# ADDENDUM NO. 3

**August 19, 2022**

## **Additions and Renovations Hawthorne Elementary School**

ADDENDUM NO: 3

**DRAWING NUMBER:**  
**C101**

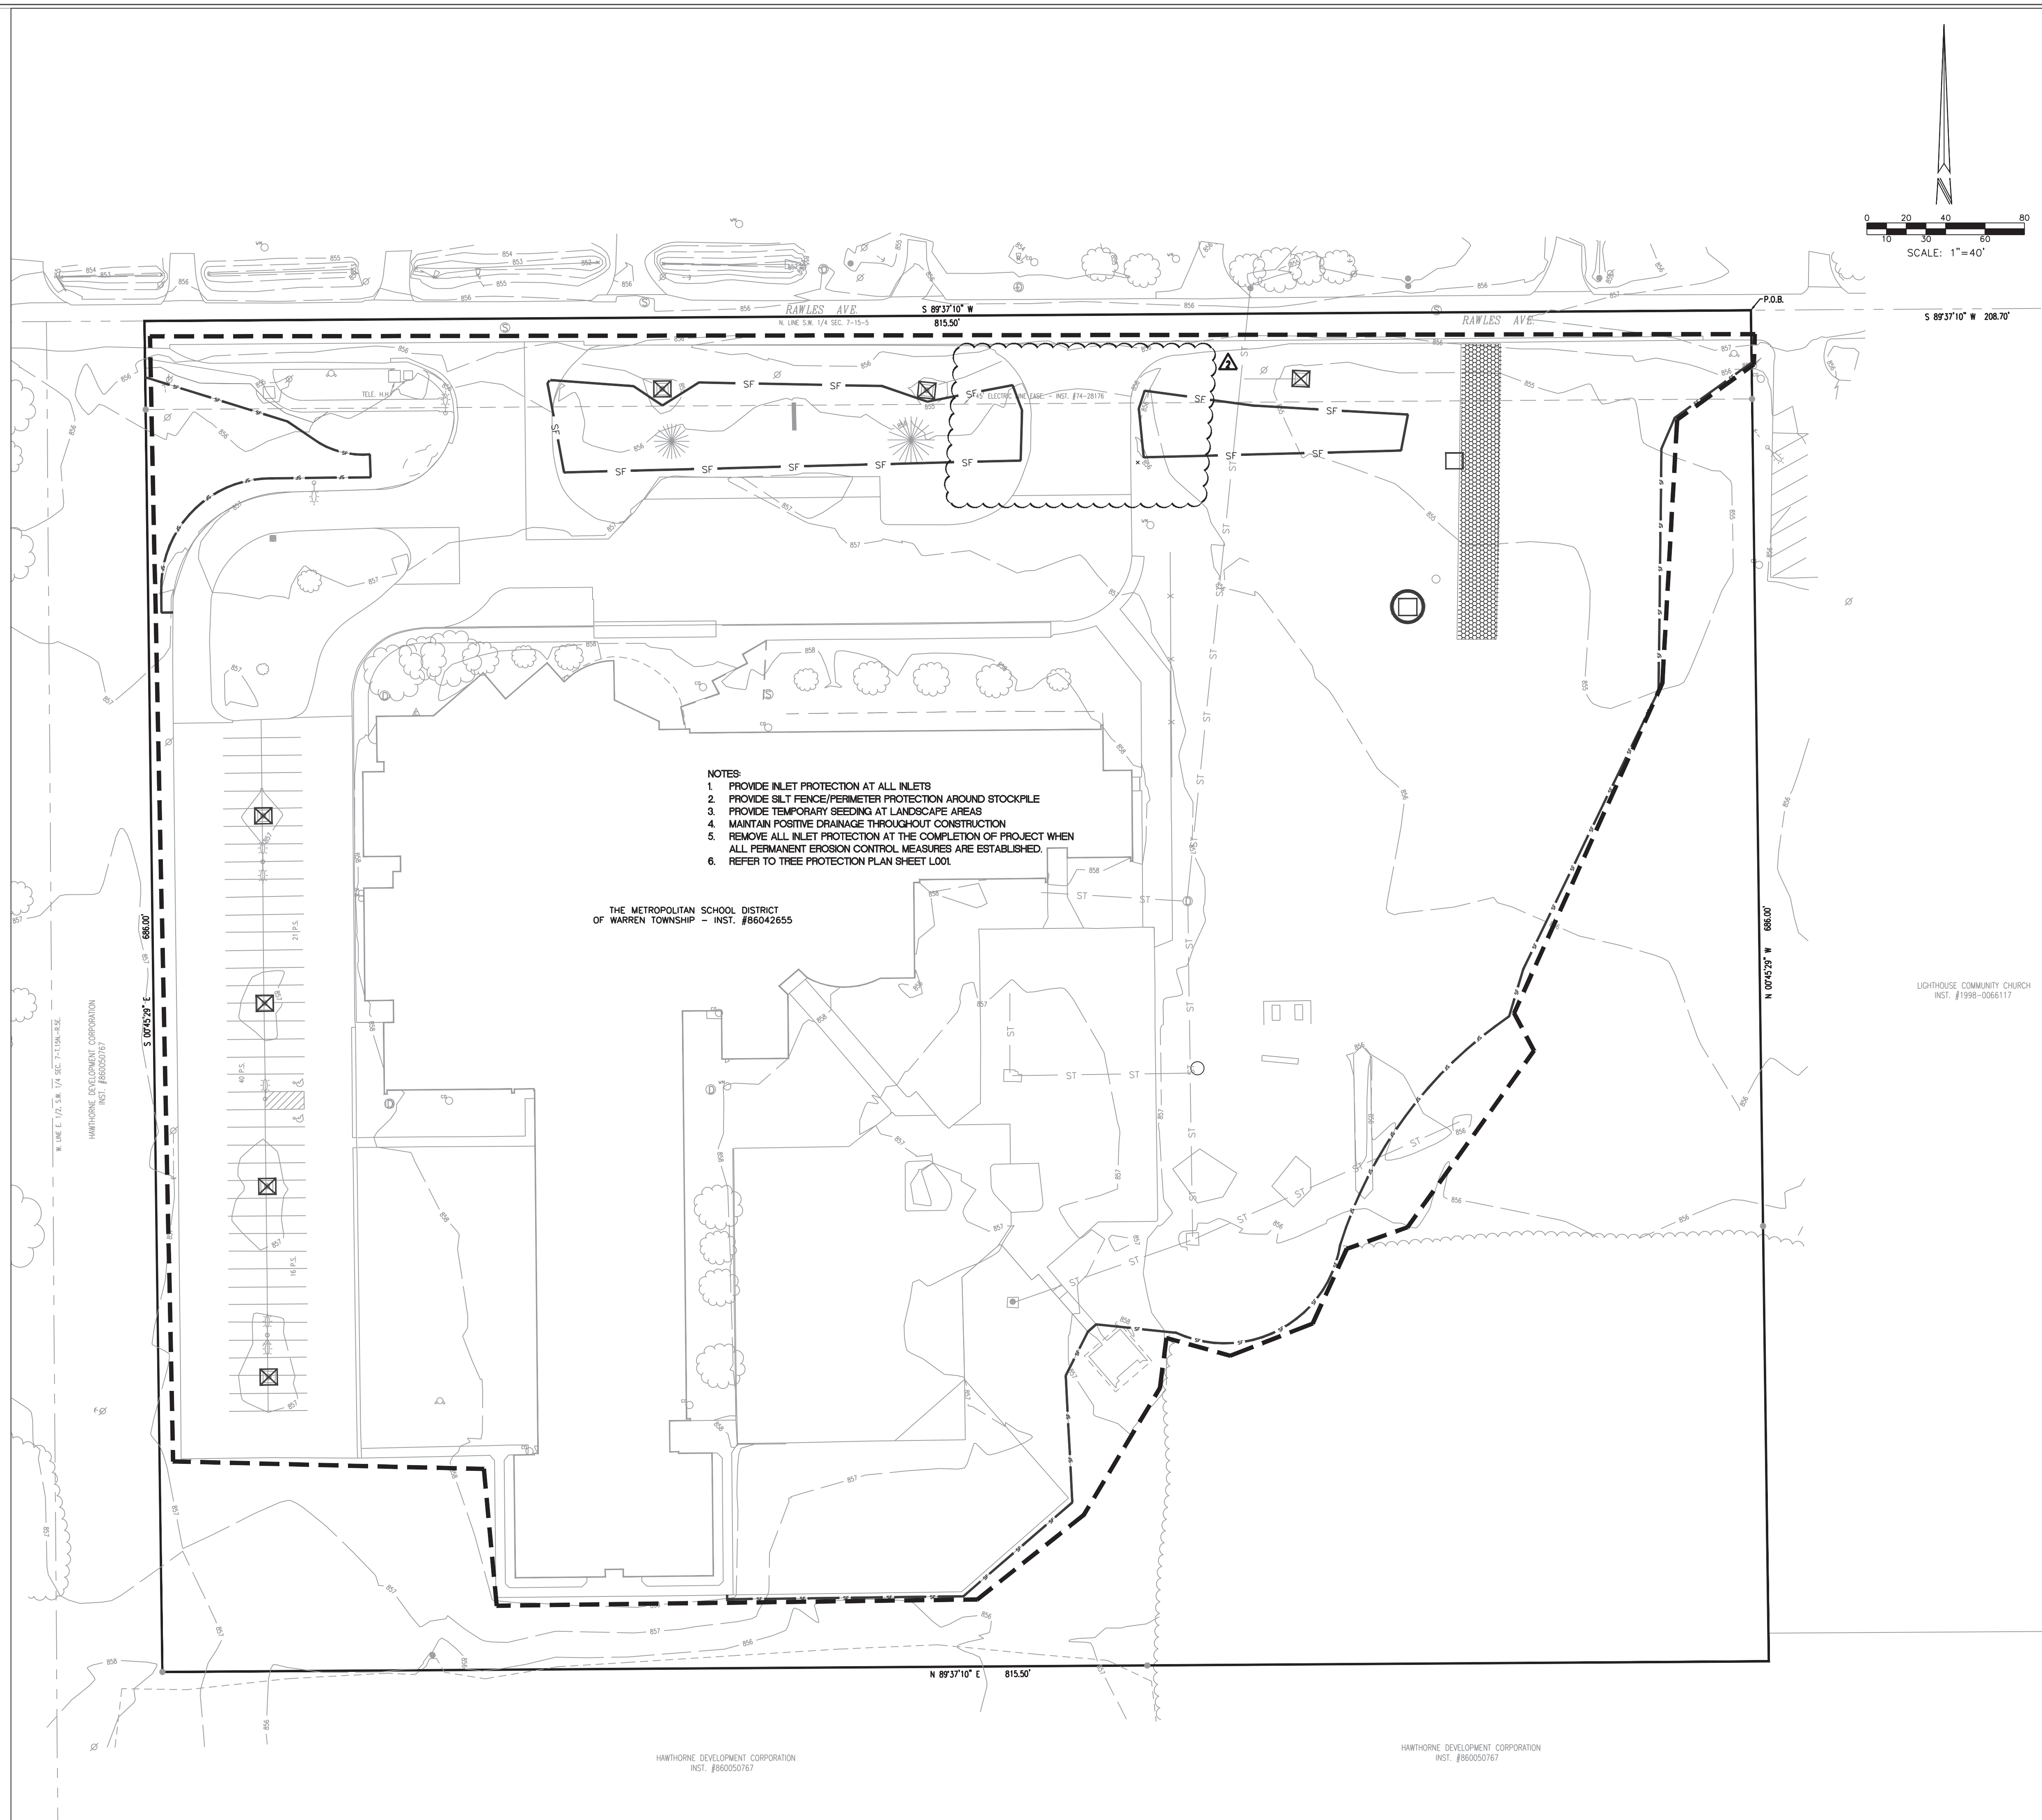
Sheet C101:

1. Added requirement for contractor to pothole the existing sanitary sewers along the west side of Unit "B" as well as along the north side of the existing building.
2. Added the demolition of the existing trees along the west side of Unit "B".
3. Added the demolition of the existing sanitary sewer along the west side of Unit "B" after the architect and engineer have reviewed the pothole data.

- 34 CONTRACTOR TO VERIFY LOCATION, SIZE, MATERIAL AND INVERT OF EXISTING SANITARY SEWER THROUGH POT-HOLING. THE RESULTS OF THE POT-HOLING SHALL BE FORWARDED TO THE ARCHITECT AND ENGINEER FOR REVIEW PRIOR TO COMMENCING THE WORK.

**DRAWING NUMBER:**  
**C501**

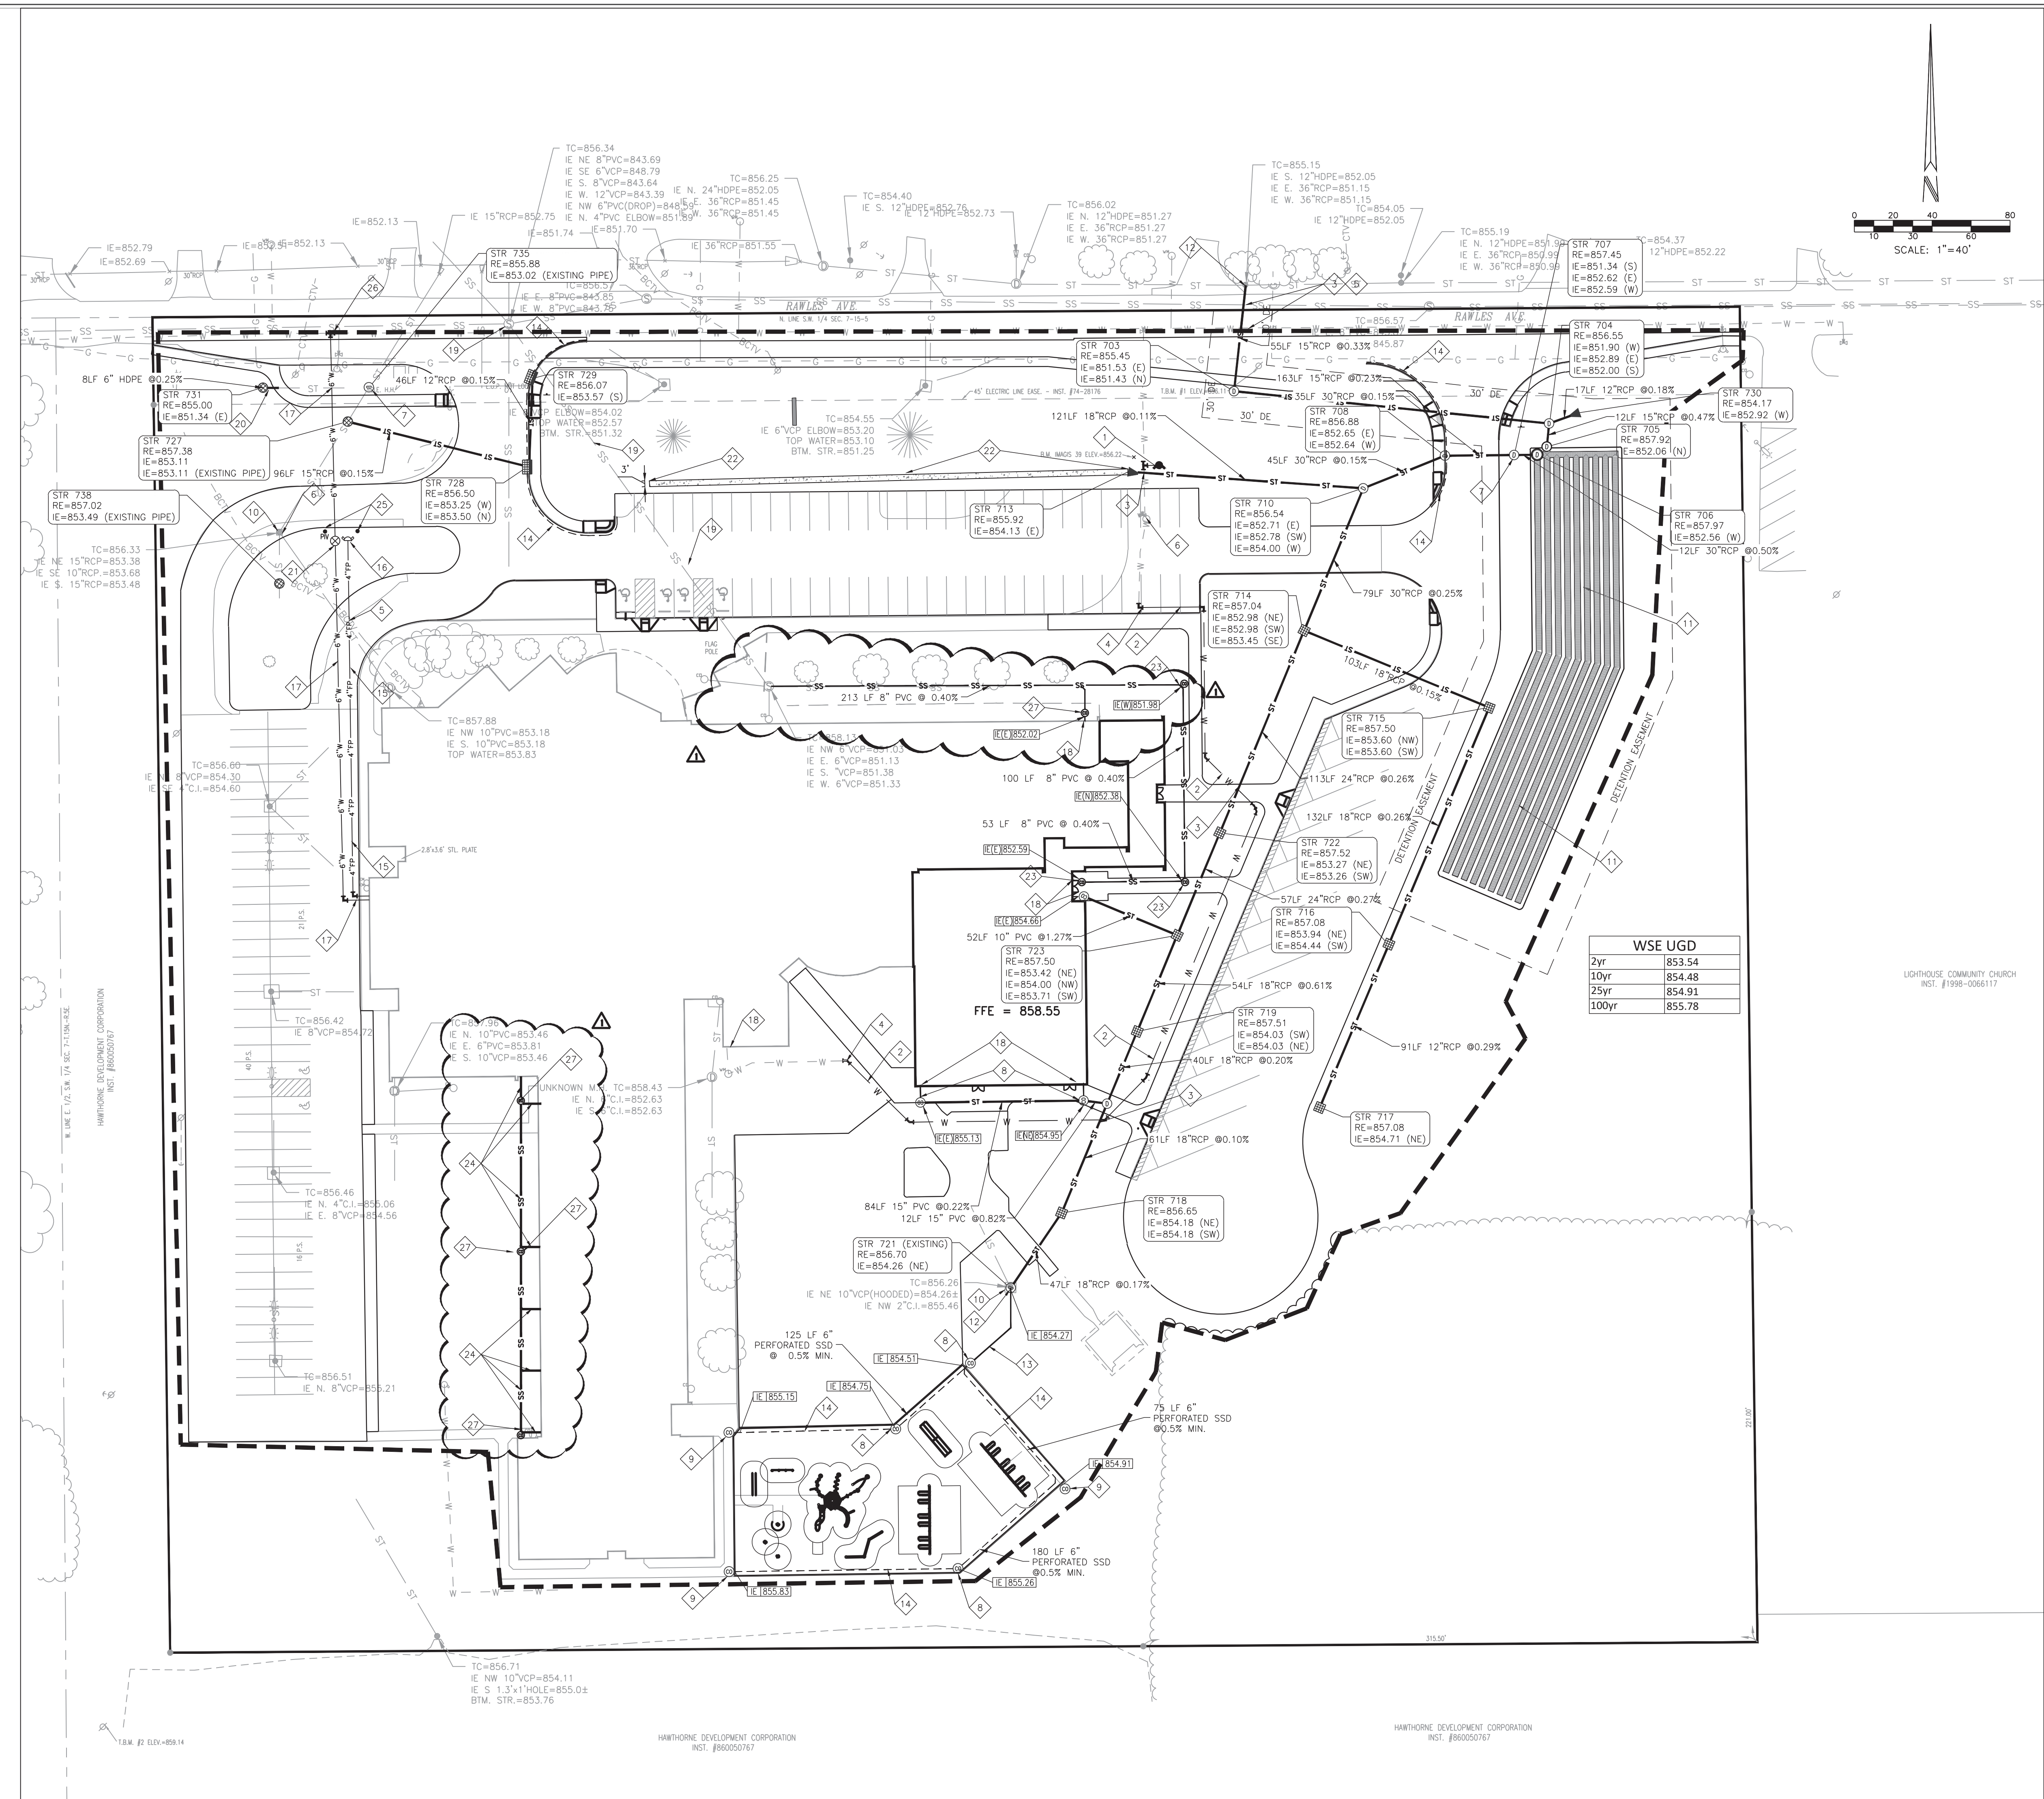
Sheet C501:

1. Removed the requirement to clean and CCTV the sanitary line directly adjacent to the north side of building the that is to be removed.
2. Added the installation of 6" sanitary sewer, five (5) lateral connections and three (3) clean-outs to replace the existing sanitary sewer along the west side of Unit "B" once the existing pothole info form the existing line is reviewed by the architect and engineer.
